PLANNING COMMITTEE REPORT

PLANNING SUB COMMITTEE A		AGENDA ITEM NO:	B4
Date:	3 rd September	NON-EXEMPT

Application number	P2019/0183/FUL
Application type	Full Planning Application
Ward	Bunhill
Listed building	Not Listed
Conservation area	Within 50m of the Bunhill Fields and Finsbury Square Conservation Area
Development Plan Context	<ul style="list-style-type: none"> - Core Strategy Key Area – Bunhill and Clerkenwell; - Employment Priority Areas (General); - Central Activities Zone; - Archaeological Priority Area - Moorfields; - Finsbury Local Plan Area – Old Street (BC3); - Article 4 Direction A1-A2; - Article 4 Direction B1(c)-C3 - Within 50m of the Bunhill Fields Cemetery – Grade I registered.
Licensing Implications	None
Site Address	IDT House, 44 Featherstone Street, Islington, London, EC1Y 8RN
Proposal	Single-storey extension at sixth floor level and partial infill of lightwell to the rear of the existing building and internal and external refurbishments to provide additional B1 floorspace and new facade appearance and associated cycle parking.

Image 9 – Proposed Front Elevation

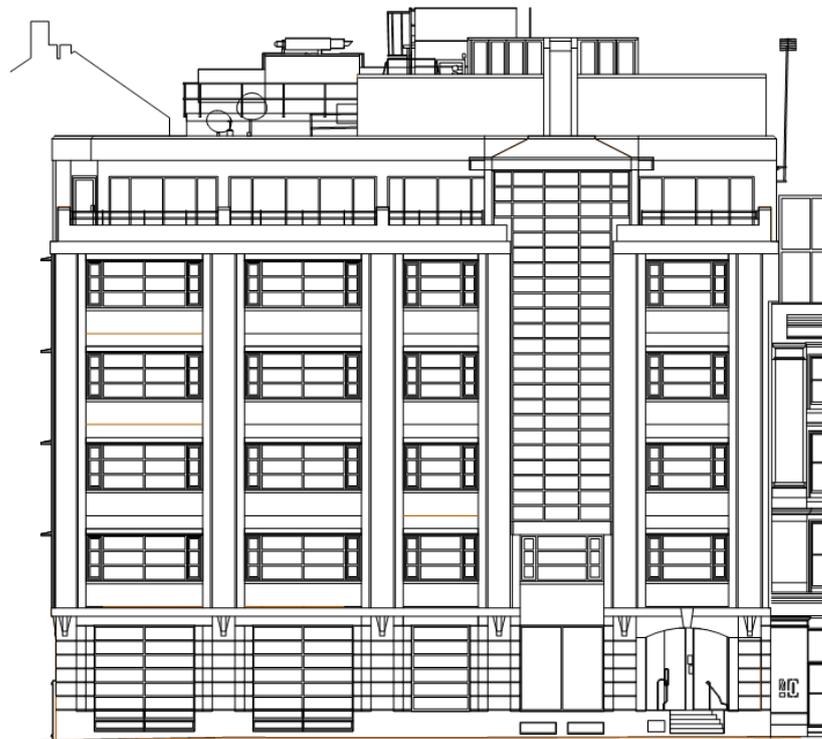
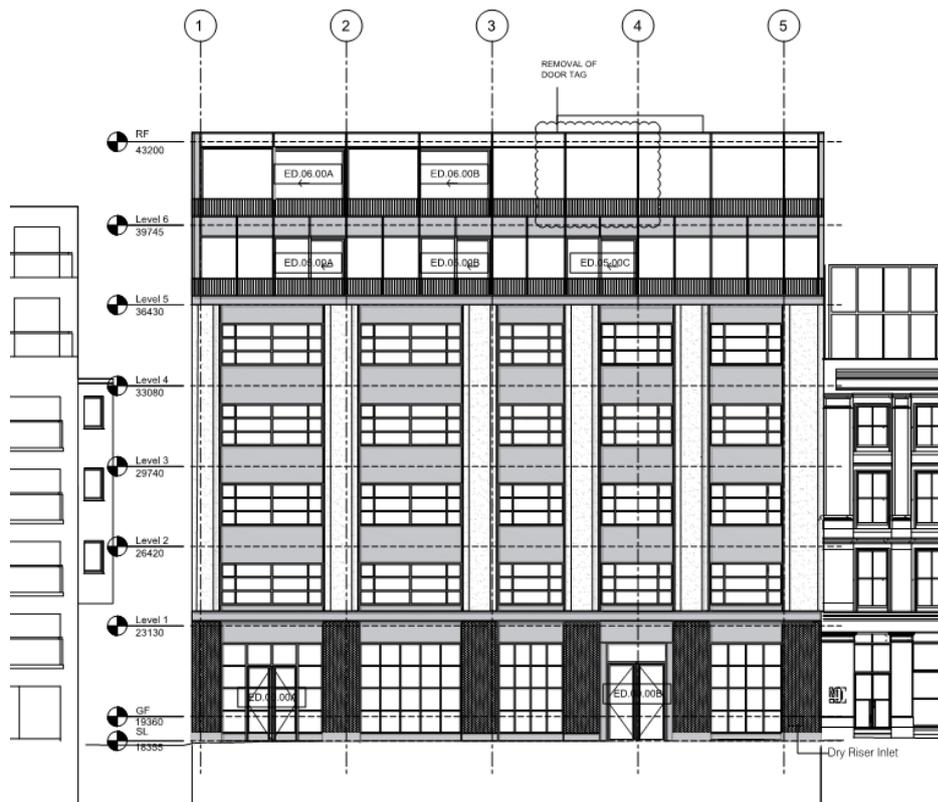
10.11 The development incorporates a new façade to the primary elevation of Featherstone Street and the west façade that fronts a shared access road with the neighbouring property, 48-50 Featherstone Street. The existing façade to these two elevations is of a mid-late 20th century design that bears little architectural significance and does not make a particularly positive contribution to the streetscape or adjoining conservation area. The ground floor is clad in granite with an art deco appearance that has some fine detailing and the upper levels are clad in mat metallic grey with a protruding glazed curved column.

- 10.12 The entire façade to both the south and west elevations are to be completely reclad. At ground floor level the Featherstone Street elevation will include enlarged windows and glazed green tiling. The main entrance will also be relocated to the west and level access provided. This ground floor treatment will wrap around onto the side access road by a single bay. The upper floors to Featherstone Street will include horizontal metal fins with dark grey matt metal panels, charcoal render columns and black aluminium window frames. The side elevation (to the access road) will be rendered in a charcoal colour with matching black aluminium window frames.

Image 11 – Front Massing Diagram

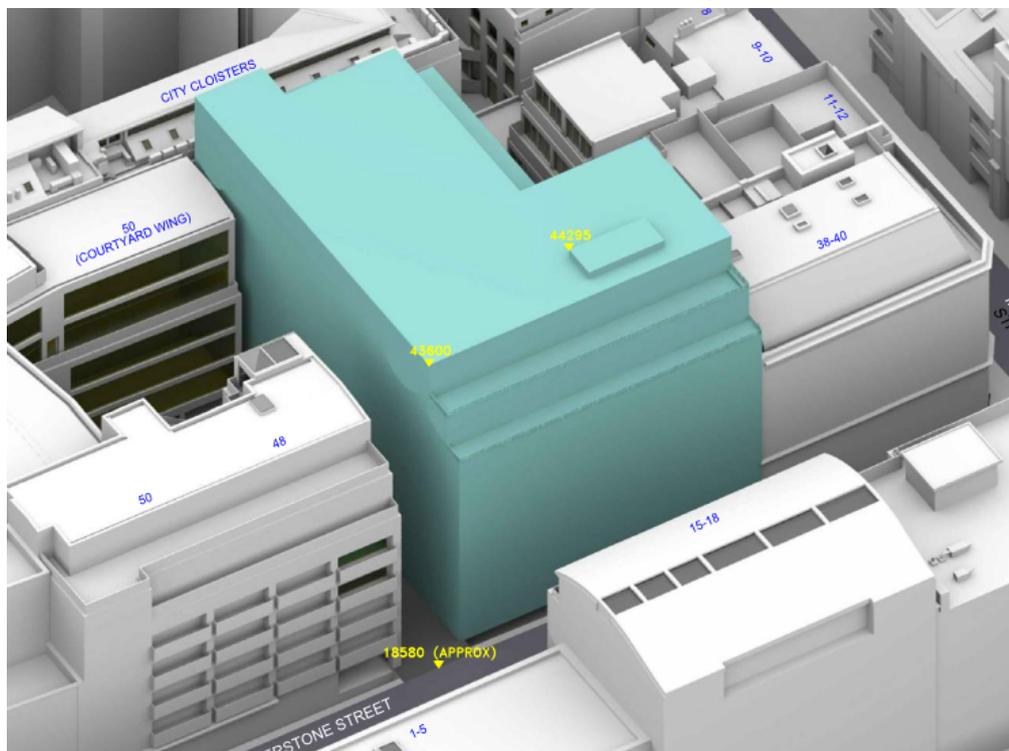
- 10.14 The proposed redesign of the building with new façade treatments, replacement extension at fifth floor level and new extension at sixth floor level are considered to be of a satisfactory design and is an improvement over the existing situation. Currently the roof top plant area that sits on top of the fifth floor represents a visually intrusive element to the building that is visible from the upper levels of surrounding buildings. It is clear that this plant has been added to over the years with little aesthetic consideration as the rooftop is only partially visible from very limited views. Despite this, the proposal to remove the rooftop plant and replace it with a sixth floor roof extension will enhance the visual appearance of the building, from both public and private views. Concern was raised from the Design and Conservation officer over the top heavy appearance of the extension in elevation view. However, this view does not accurately portray how both the sixth and seventh storeys are set back and taking this into consideration, along with the fact that this view is only possible from a limited number of private views, the slightly higher proportion of the top floor is acceptable and does not represent an unacceptable effect on the townscape nor have a negative effect on the adjoining conservation area.

Image 15 – Proposed First Floor Plan

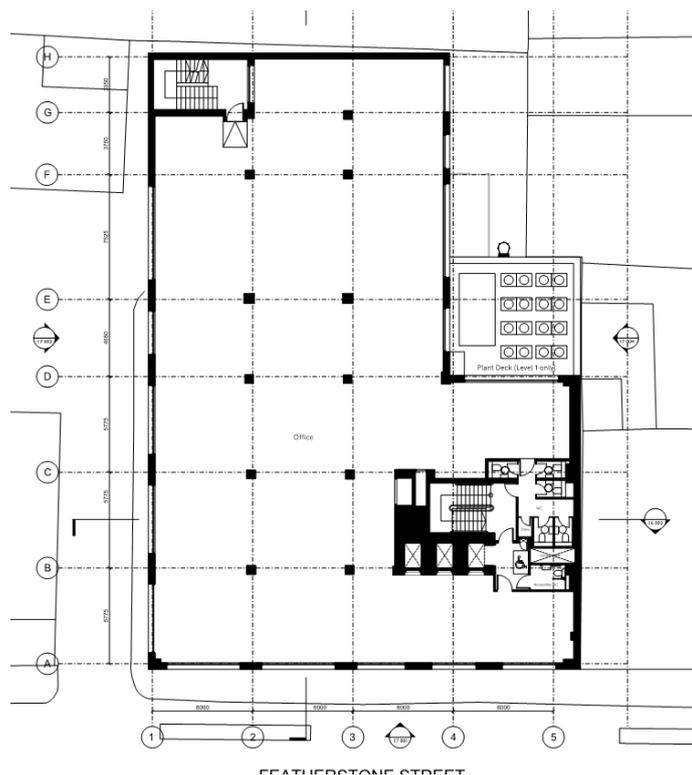
- 10.23 The plant at first floor level will be surrounded by an acoustic enclosure, the details of which will be submitted to the council in line with the requirements of condition to ensure the plant machinery in this area does not adversely affect surrounding occupiers a further condition will be included that requires the plant machinery to operate at least 5dB(A) below the background noise level.
- 10.24 An additional plant area will be positioned on the top floor extension next to the lift overrun. The sound emitted from this plant area will also be controlled via condition to protect the amenities of surrounding occupiers.

Image 16 – Daylight Distribution Contour Lines for 9-10 Mallow Street

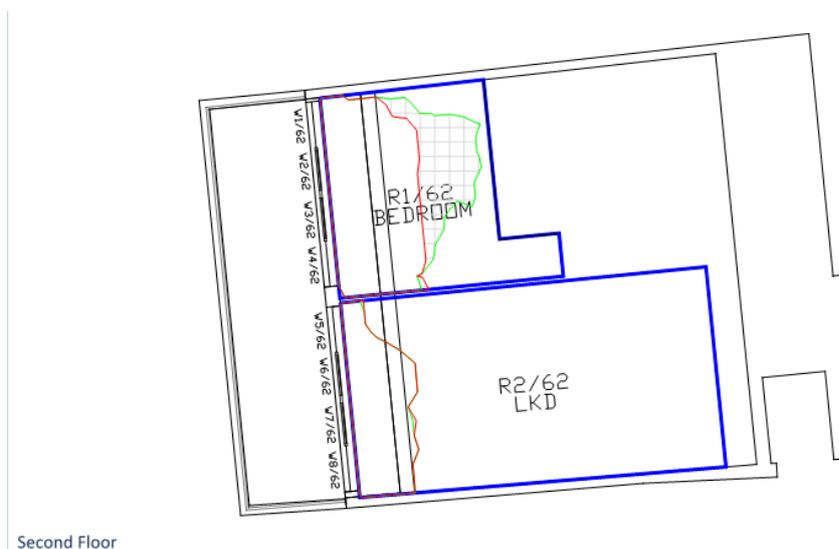
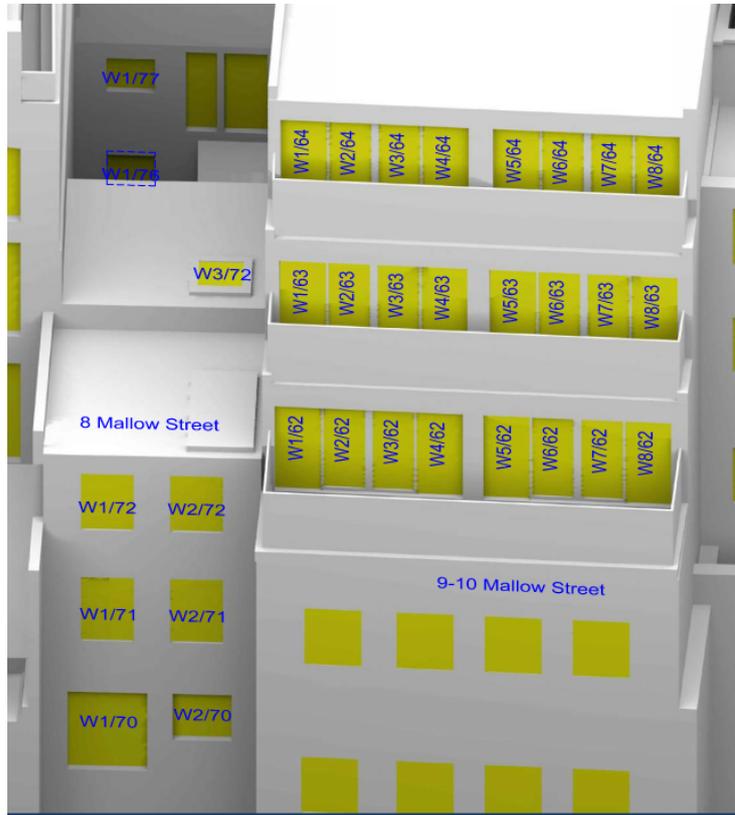
- 10.36 The contour lines for these two rooms indicate that while the reductions are above the 20% figure suggested by BRE guidance, the rooms will not be impacted to such a degree that would be detrimental to the amenity of the residents of these units. The effected room to 9-10 Mallow Street is a bedroom where there is more flexibility when applying BRE guidance as main habitable rooms (living rooms) are of most concern when considering acceptable light reductions. The reduction of 28.4% is therefore acceptable in this instance as it still falls below 30% which is often deemed acceptable in a dense urban environment, such is the case with the area to the rear of 9-10 Mallow Street. The reduction figure of 22.3% at 15-18 Featherstone is sufficiently close to the 20% guidance figure as to also be deemed acceptable in this instance.

- 10.37 An objection has been received from an office unit at 9-10 Mallow Street, raising concern over the potential effect on the working environment at this property due to reduced sunlight and daylight. The property is listed under appendix 3 (windows map) of the updated report as W1-W4/60 9-10 Mallow Street (drawing number P1978/WM/02 Rel:10). BRE guidance prioritizes the effect on residential units but it does state that the guidance can be applied to ‘some office’ development (Paragraph 2.2.2 of the 2011 BRE Report).

10.39 The infill extension to the rear of the building is stepped away from Mallow Street from fourth to sixth floor levels to address concerns that were initially raised. Therefore, this element of the development has been modified to address the potential sunlight/daylight effects on the premises along Mallow Street that adjoin the application site. Given the existing situation, the alterations that have been made to the massing and the updated results provided for surrounding units, it is concluded that the effect on VSC to both the ground and first floors units at 9-10 Mallow Street will be permissible under BRE guidance.

Image 20 – Swept Path Analysis for Larger Servicing Vehicles

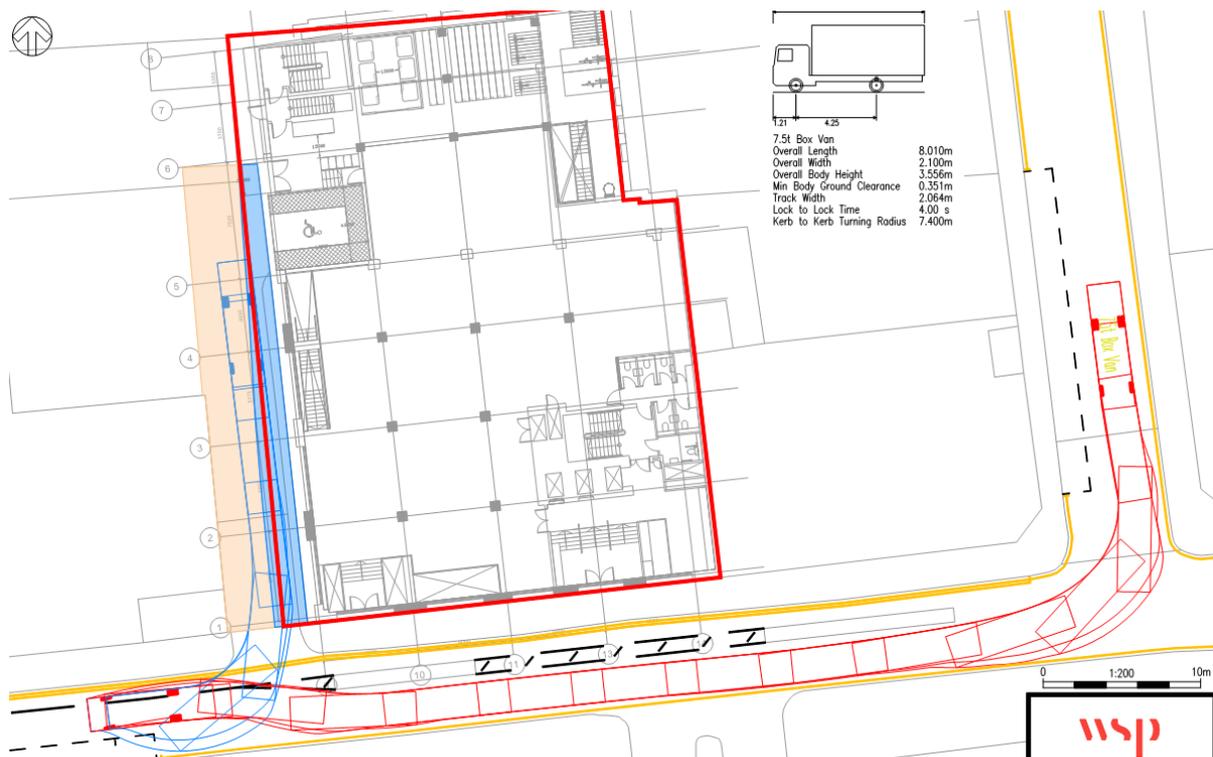
10.47 Three objections were received that raised concerns over access to the adjoining rear courtyard to 48-50 Featherstone Street during the construction period. These concerns were raised to the applicant who provided a Logistics and Traffic Management Plan to address the objections. The document confirms that the construction scaffolding can be erected in such a way as to not obstruct access for private vehicles or for emergency service vehicles by having a 5m clear headroom.
